M E M O R A N D U M

Date: November 18, 2014  
To: Hugh Russell, Chairman, Cambridge Planning Board  
From: Tanya Iatridis, Senior Director of University Planning, HPPM  
Copy: John Haigh, Executive Dean, Harvard Kennedy School of Government  
Re: Planning Board Requirements – Special Permit Application #293

To: Harvard  
From: CDD Staff  
Date: November 4, 2014  
Re: **Harvard Kennedy School of Government – Planning Board requirements**

# BELFER CENTER ENTRY - ALTERNATE PROPOSAL

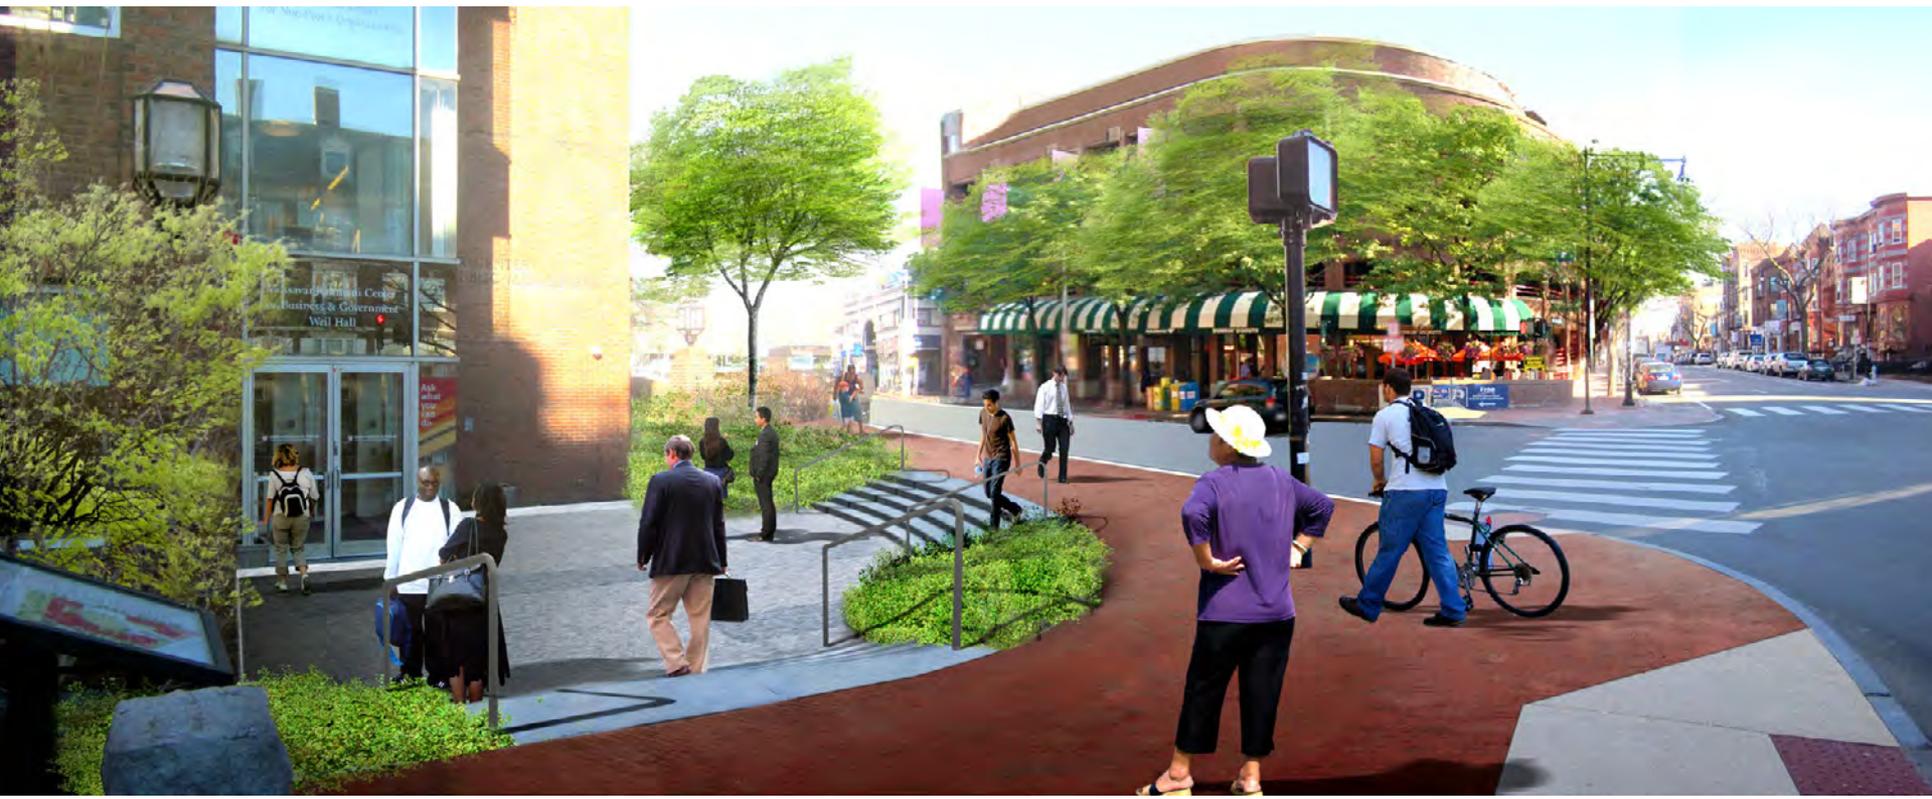
- The sunken Belfer Center entry appears out of scale with the small entry door. There is a need to review the scale and break down the stairs at this entrance, as well as address safety concerns associated with falling down /into the entry. Consider additional landscape treatments such as planters and seating.
- Concerns regarding loading are outstanding. Provide further detail on proposed loading operations, including how deliveries will be scheduled e.g. loading door will be kept open at peak times. Clarify the Eliot Street service entrance dimension – does the 45' include the sidewalk?
- The issue of how vehicle drop-offs will be managed remains a concern. Provide further detail on possible solutions to managing this issue, including ways to prevent vehicles standing in the Eliot Street bicycle lane.

In response to comments received from both the public and the Planning Board, the design of this entry area has been modified to incorporate additional landscape elements at either end of the entry stairs and within the central portion of the stairs (See Attachment 1-2). To address safety concerns, hand rails have been placed at the outer edges of the stairway sections. In addition, brick paving is proposed for the sidewalk directly adjoining the entry area. The proposed condition will significantly improve the public realm at this location by increasing the width of a very active sidewalk at this corner.

# GATEWAY BUILDING

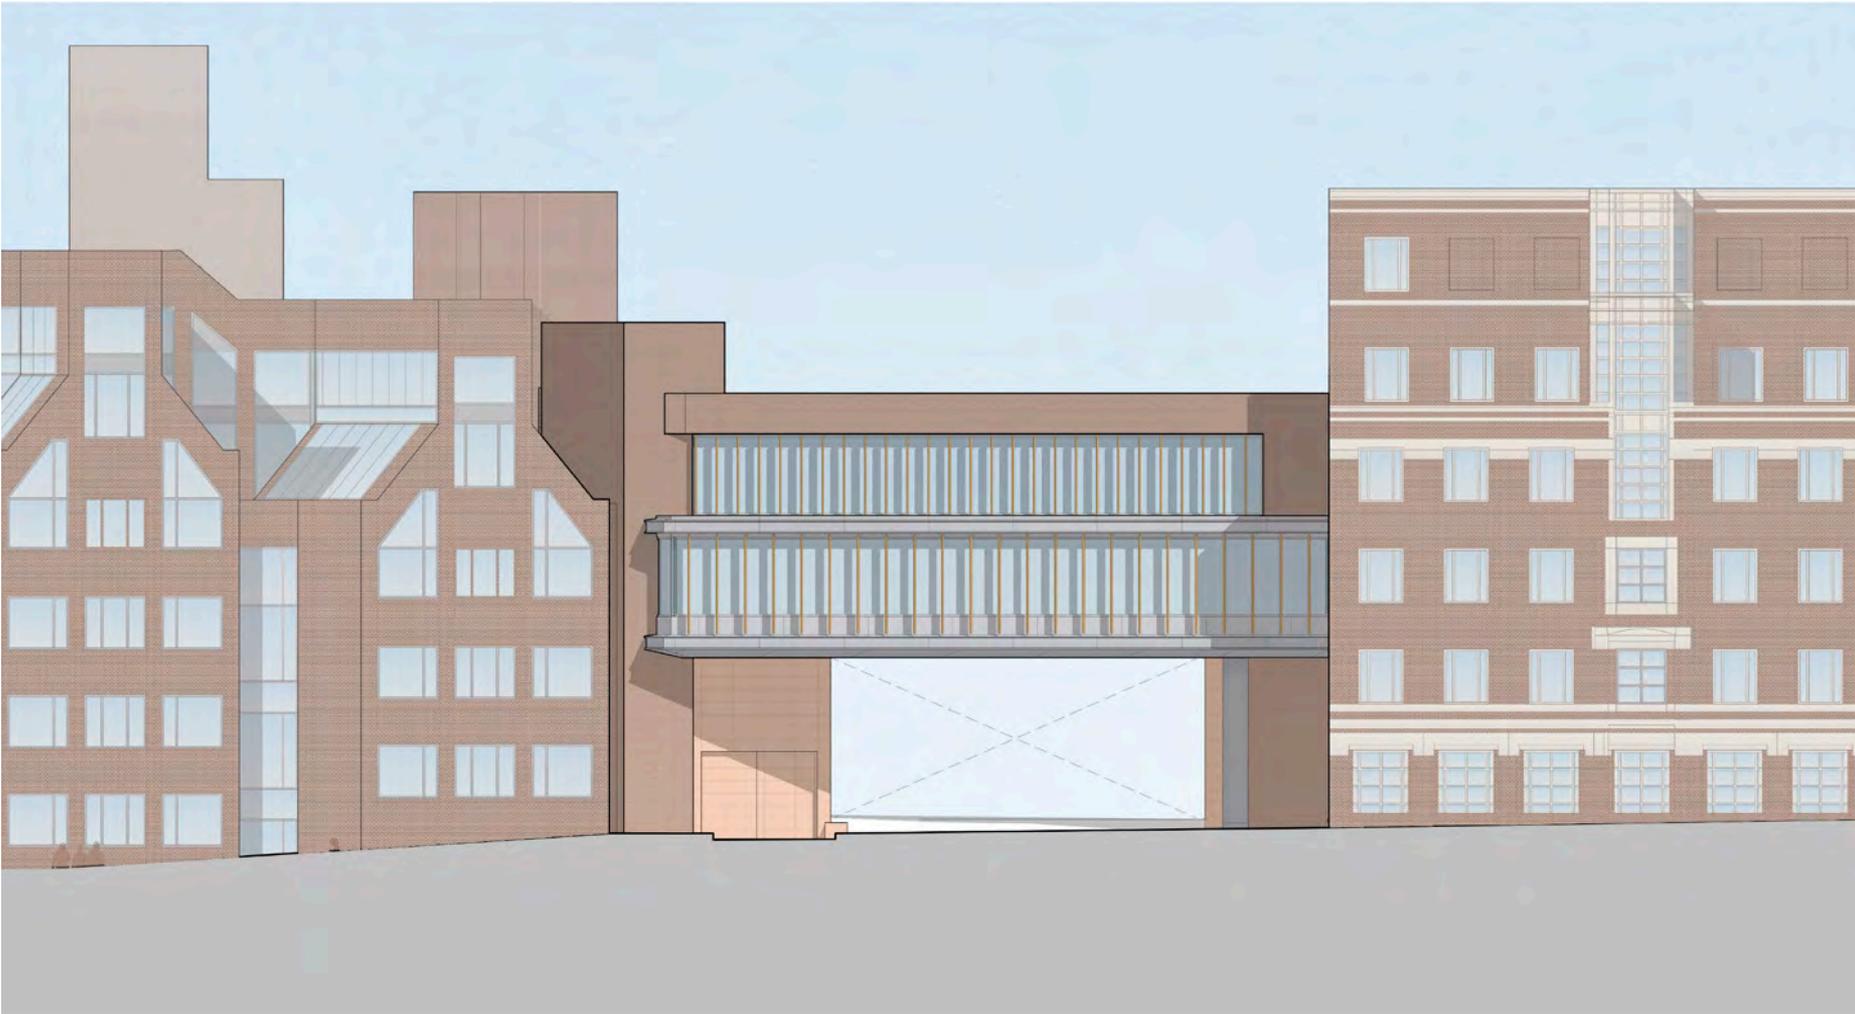
- The architectural treatment of the connecting buildings requires further consideration. The vertical scale of the connectors, as well as their architectural quality, needs review in order to make a more positive contribution to the surrounding streets and public spaces. Some ideas to consider include: further setting back the upper levels, reducing or lowering the cornice, different glazing treatments, etc.

- The Planning Board needs to be convinced that the proposed architectural treatment and massing is the right outcome. As such, show design alternatives or evidence of further study to demonstrate why the selected option was chosen.

HKS and its design team have studied many possible approaches to the architectural treatment of the proposed connector buildings (See Attachment 3-1). The design of the Gateway Building, as initially presented in the Special Permit application, incorporated key design modifications from the building's earlier conceptual studies including stepping back the building's upper level to reduce its apparent massing, the introduction of a brick cornice to strengthen the visual relationship between the addition and the existing Taubman and Belfer buildings, and a simplification of the proposed façade treatment.

In response to comments at previous the public hearings, the design team has continued to study the façade treatment of the Gateway and West buildings and is proposing further modifications of their articulation. In order to diminish the verticality of these facades the spacing of "fins" on the lower levels of both buildings has been expanded to 3' - 4" (from 2' - 6" in the West Building), in addition this detail is no longer being proposed for the upper level of the Gateway Building. (See Attachment 3-3; 3-5)

# WEST BUILDING

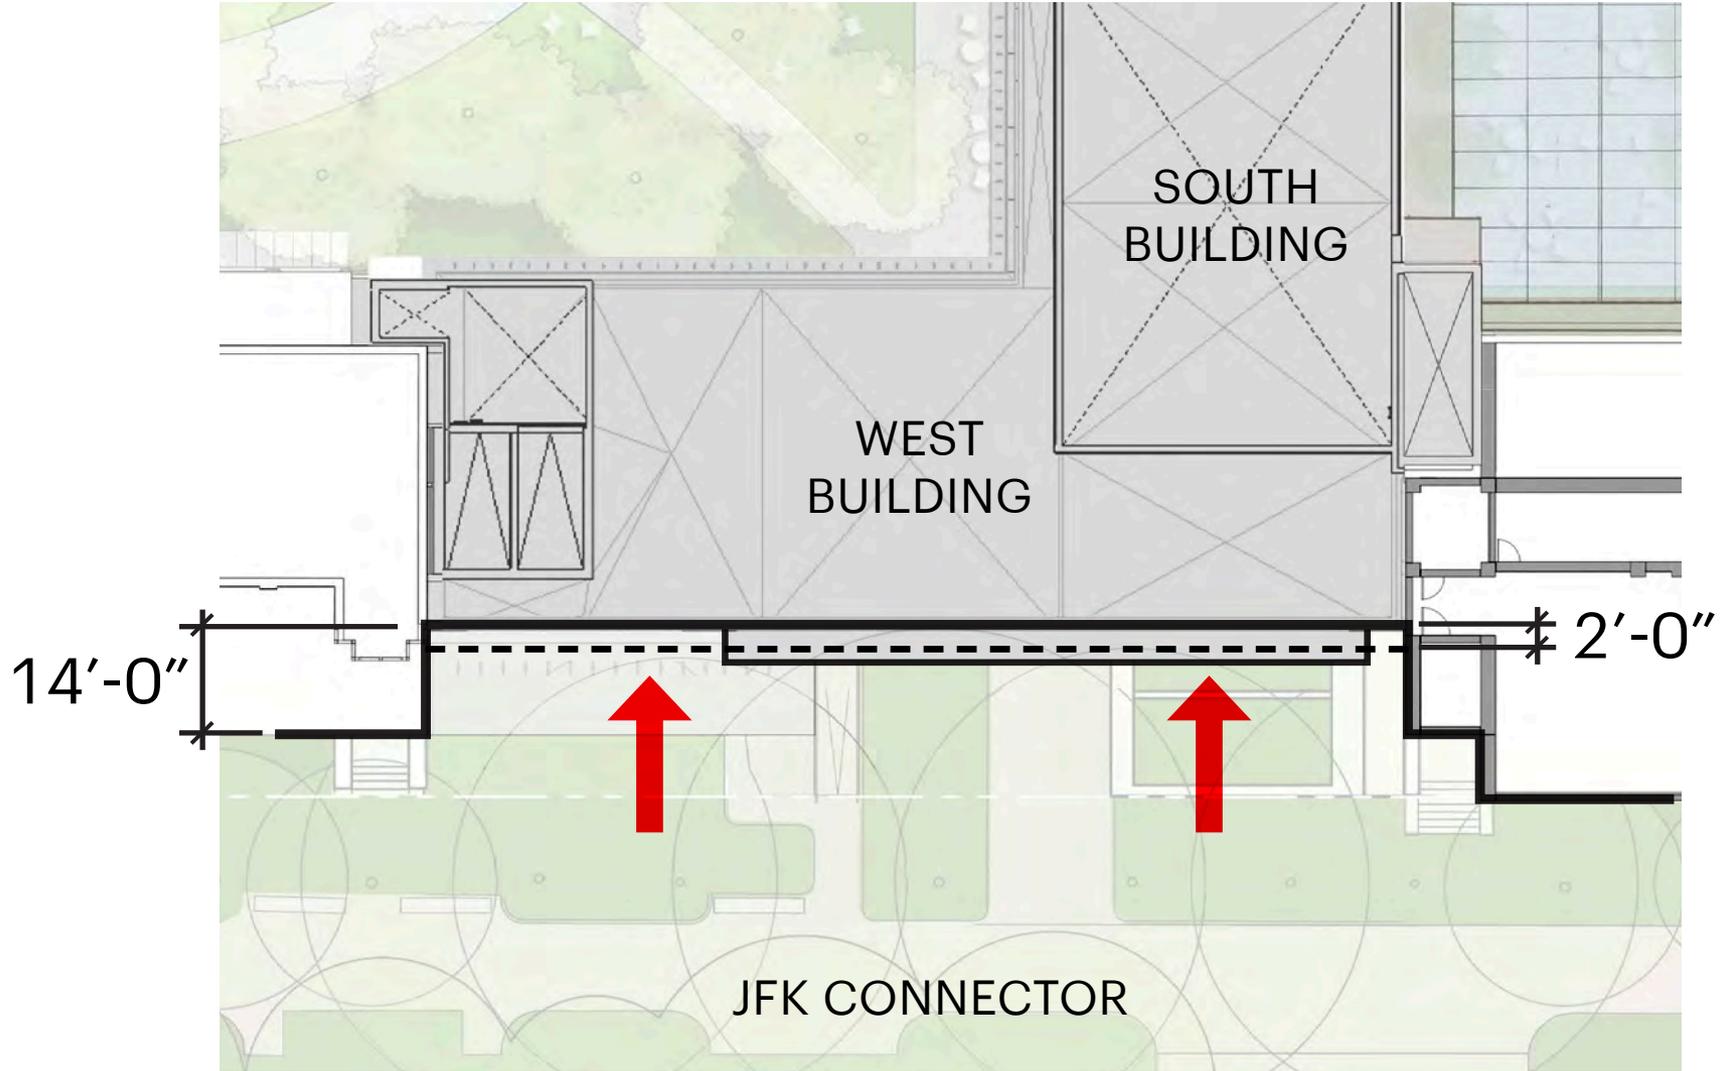
- There is some concern that the JFK walkway connector is a mismatch architecturally and does not have the right relationship with the allée. The perspective view of this entry provided in the application materials appears cluttered and lacks interest. This needs further consideration.

Early in its planning process, HKS and its design team undertook design studies of possible options for the architectural treatment of the proposed West Building (See Attachment 4-1). The design of the West Building as initially presented in the Special Permit application is the result of a careful assessment of several important considerations including the building's relationship to existing campus buildings, its location along the pedestrian pathway, its role as a new entrance to the campus, and the appropriate expression of the program within the building.

# WEST BUILDING ELEVATION - 3'-0" HEIGHT REDUCTION

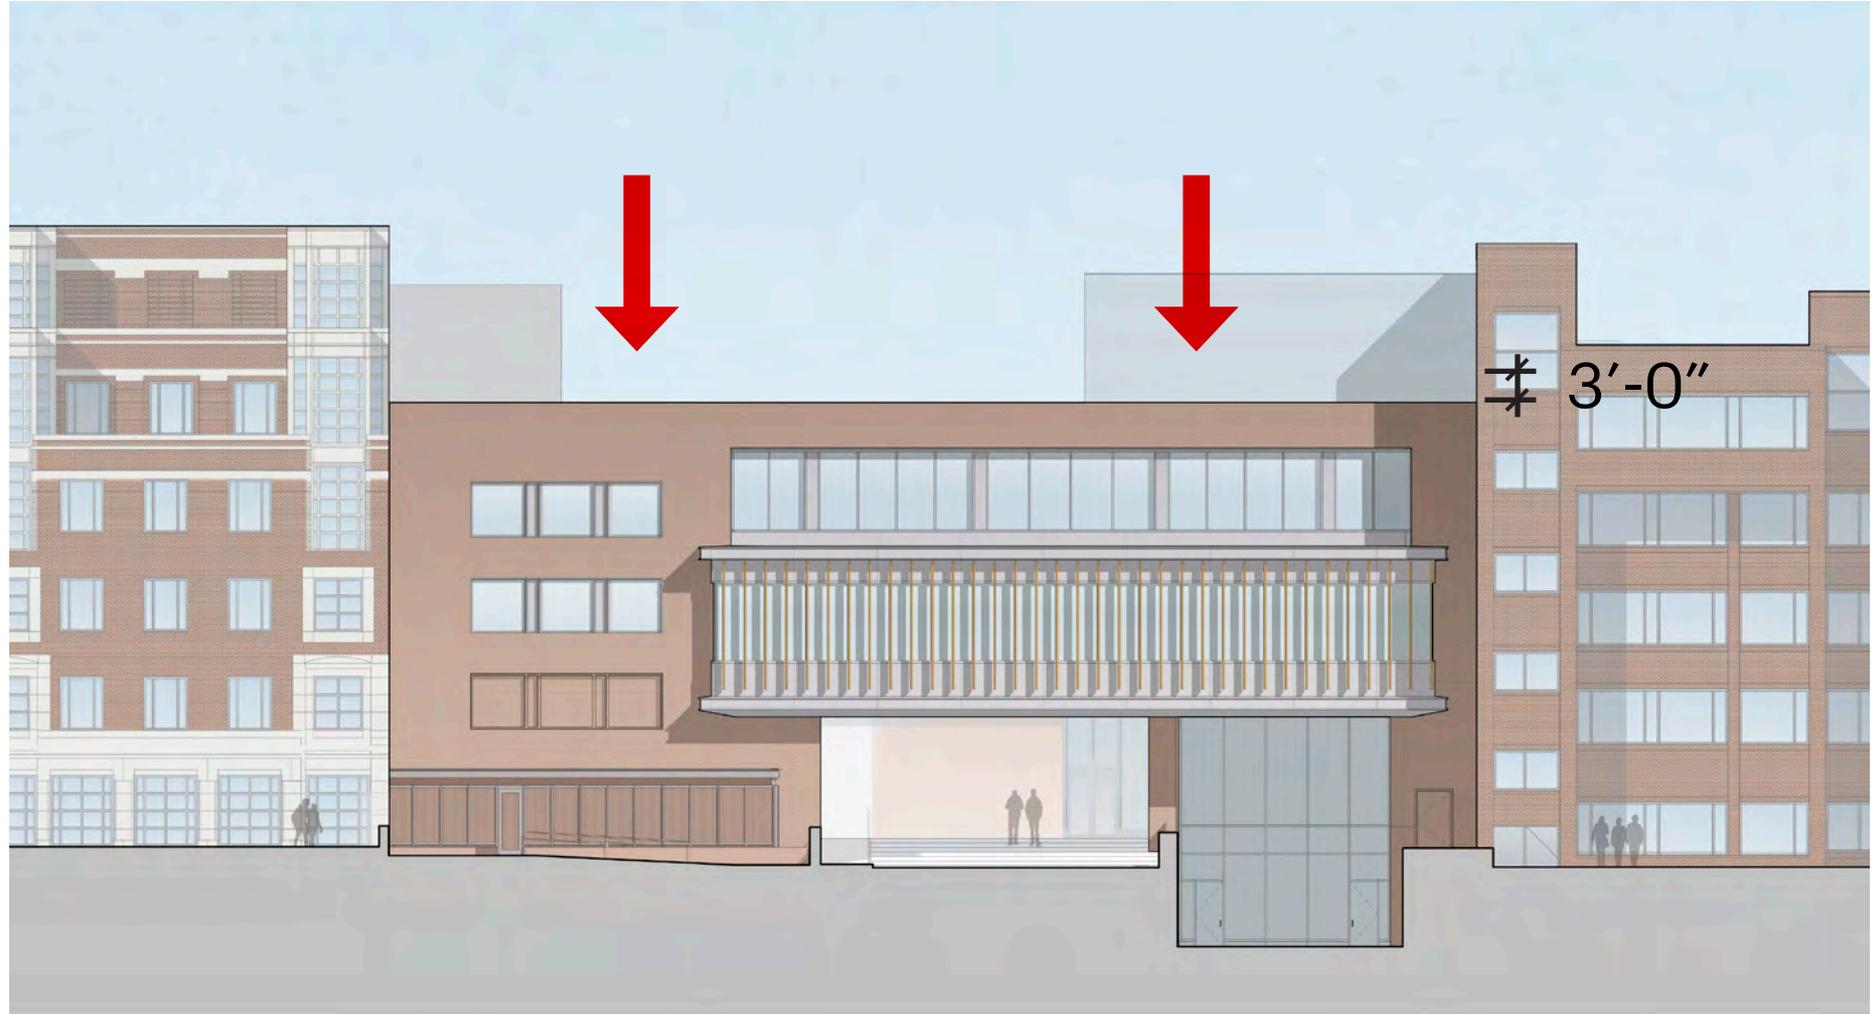
- Provide a response to public concerns raised about shadow and sky view impacts on the JFK walkway. Questions to consider include: How does the entrance affect the walkway? Is it intended to be part of a memorable walking experience? How can shadow impacts be minimized?

Second, the height of the West Building has been reduced by three feet (See Attachment 4-3). This change is in addition to the previous modification that moves the mechanical penthouse back from the façade a total of 24 feet. These changes will further reduce the visual presence of this addition along the pedestrian walkway. Also, as previously noted, the spacing of the "fins" on the lower level has been expanded to 3' - 4" (from 2' - 6") consistent with the detailing of the Gateway Building (See Attachment 4-5).

# ELIOT STREET SECTION

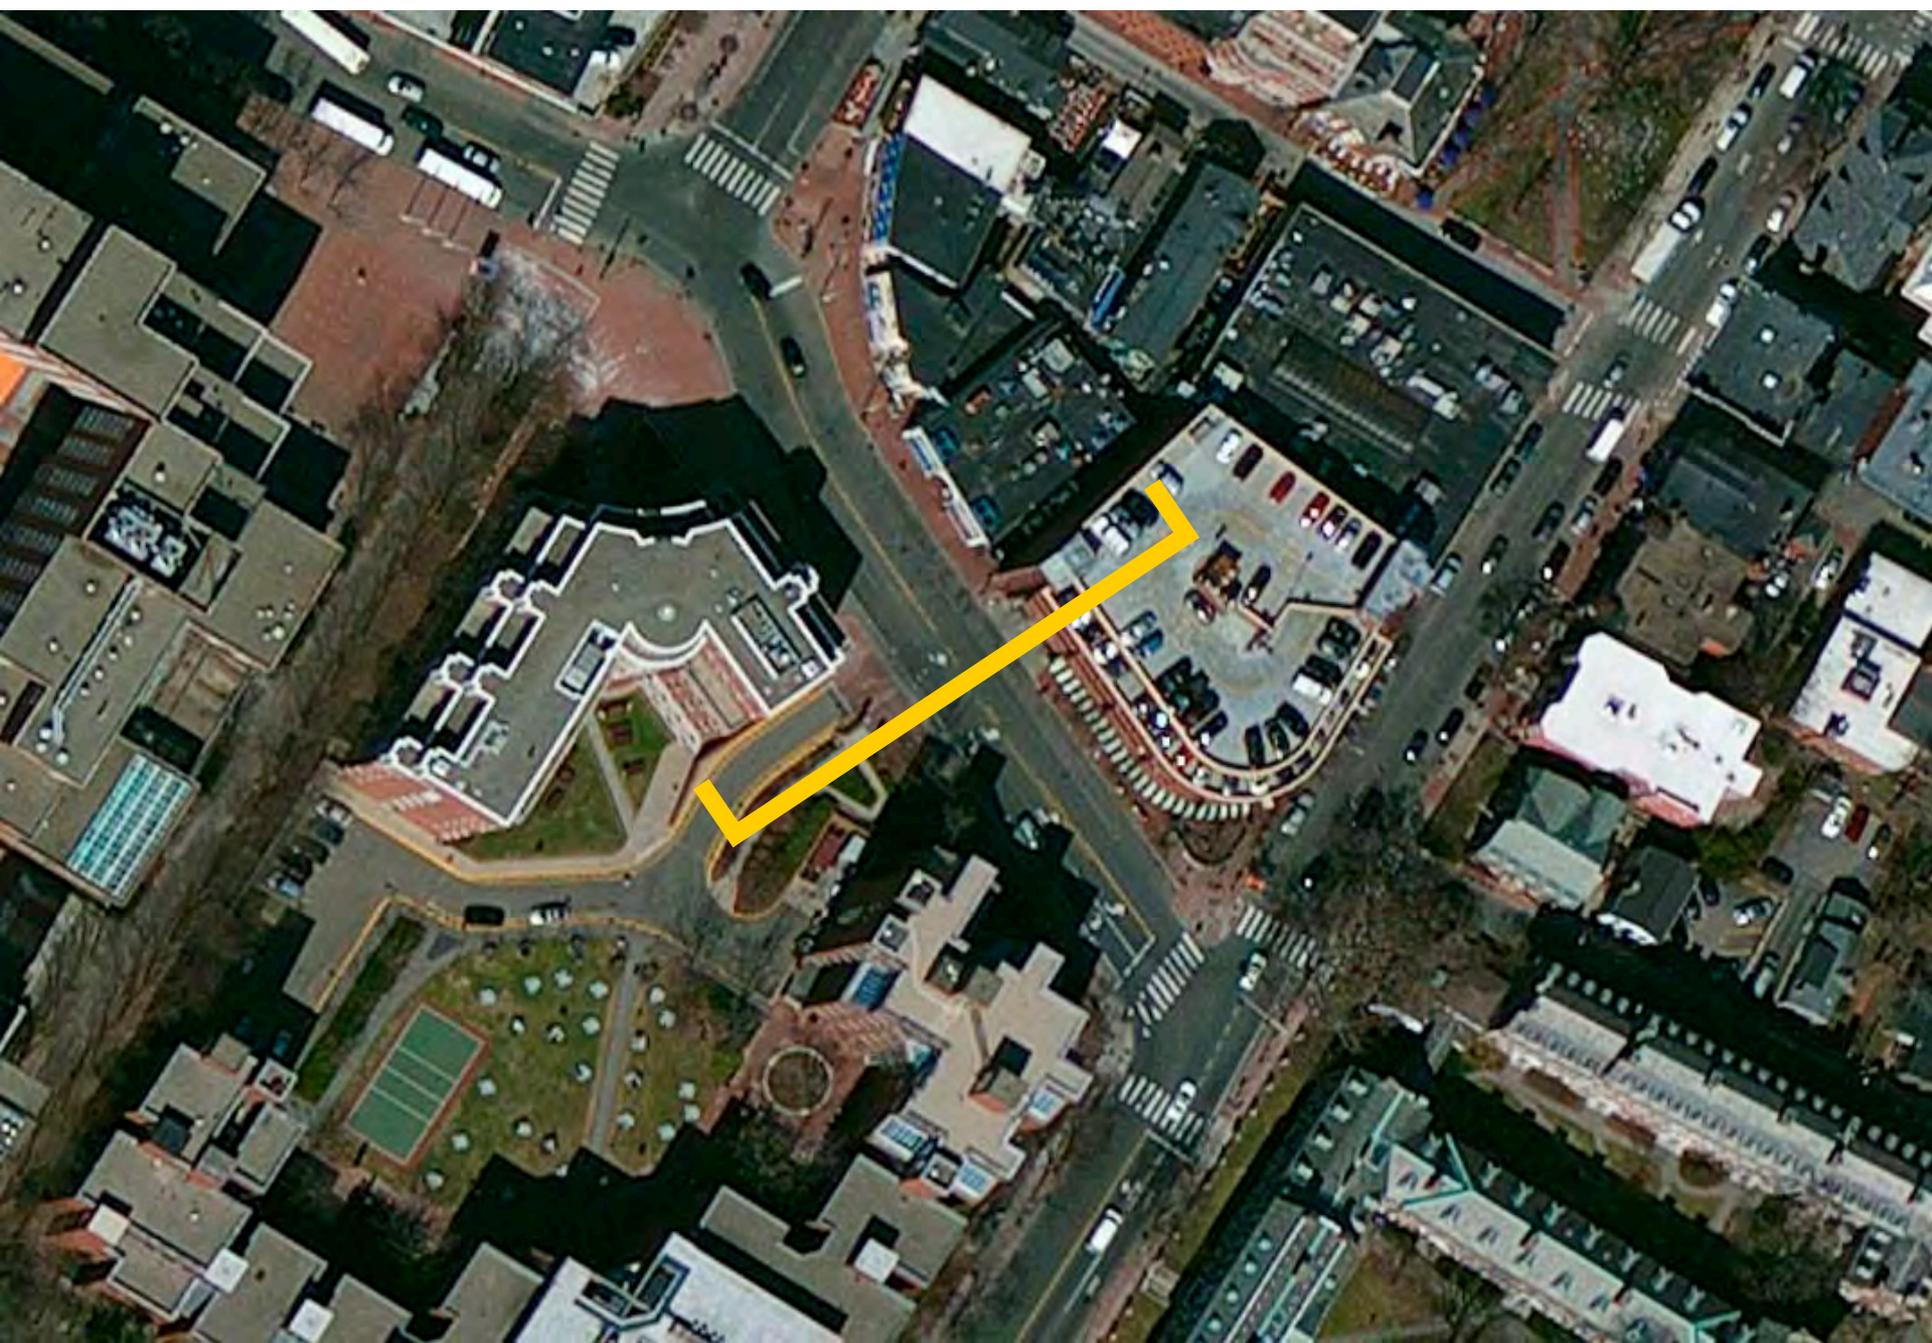
- There appear to be some errors in the Eliot Street section presented at the last hearing - review dimensions and scale.

The drawing submitted at the October 28, 2014 public hearing, titled “Eliot Street Section at the Gateway Building” has been revised to correct the indicated dimensions and scale (See Attachment 5).
